Response to a Request for Additional Information regarding BAW-10241(P), "BHTP DNB Correlation Applied with LYNXT"

Response to a Request for Additional Information (RAI) on BAW-10241

Subject: Extension of the BHTP CHF Correlation Ranges

Figure 1
BHTP Calculated CHF versus Quality at CHF
Actual Data Points in Various Regions

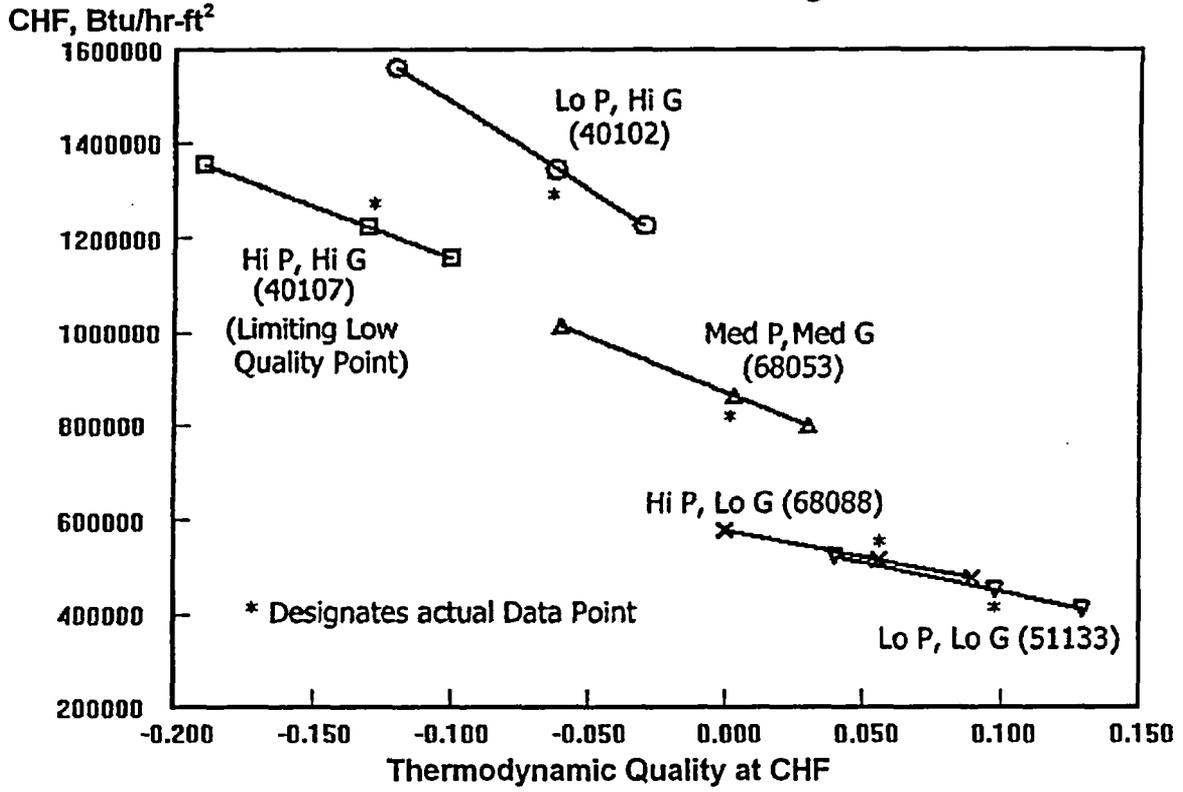
- 1. In order to justify even a relative minor extrapolation of a correlation beyond its database, it is necessary to examine the correlation's behavior very carefully in the extrapolated region, to be certain it maintains the expected trends. The plot in Figures 1 and 2 shows that the BHTP does exhibit the expected behavior, but the examples shown are for only two data points, both of which is at mass flux values near middle of the range of normal operation. Would the correlation show the same trends at very low mass flux? At very high mass flux? At low pressure and low mass flux? At high pressure and low mass flux?*

- 2. Because the correlation is non-linear in the independent parameters, the example of one or two data points in the middle of the range, as presented in Figures 1 and 2, is not sufficient to demonstrate the general applicability of the correlation to this extended range. In order to show that the BHTP correlation appropriately captures the trend of thermodynamic quality versus critical heat flux, and that of the pressure versus critical heat flux, over the full operating range of mass flux and pressure, please provides a family of curves like those in Figures 1 and 2. These curves need to encompass the full range of mass flux and pressure starting at the lowest thermodynamic qualities tested. If the correlation is able to hold up through this extrapolation, then the additional curves should all look very much like the examples in Figures 1 and 2, and it will have successfully demonstrated the applicability of the correlation when extended beyond its database over the relatively small range of extrapolation considered.*

The lower quality limit for the BHTP CHF Correlation is -0.1301 . If, during calculation of CHF at any axial location of CHF, a quality below this limit is encountered, the quality used in the calculation of the BHTP CHF is raised to this limit (-0.1301). Figure 1 and its accompanying table show that this technique is conservative in all of the PG (pressure, P, versus mass velocity, G) regions.

To illustrate the conservatism of this technique, examine point 40107 with the actual quality limit of -0.1301 . The BHTP calculated CHF for these conditions is $1,221,918$ Btu/hr-ft². If the quality upstream of this data point was, for example, -0.190 then (as shown on Figure 1) the BHTP calculated CHF would be $1,353,881$ Btu/hr-ft². Thus the technique of increasing the quality from -0.190 to -0.1301 is (in this case) conservative by $131,963$ Btu/hr-ft² (the difference between $1,221,918$ at a quality of -0.1301 and $1,353,881$ at a quality of -0.190). Figure 1 shows that there would be varying degrees of conservatism in different PG regions. However, the technique is seen to be conservative in all regions since a negative slope is always observed with increasing quality.
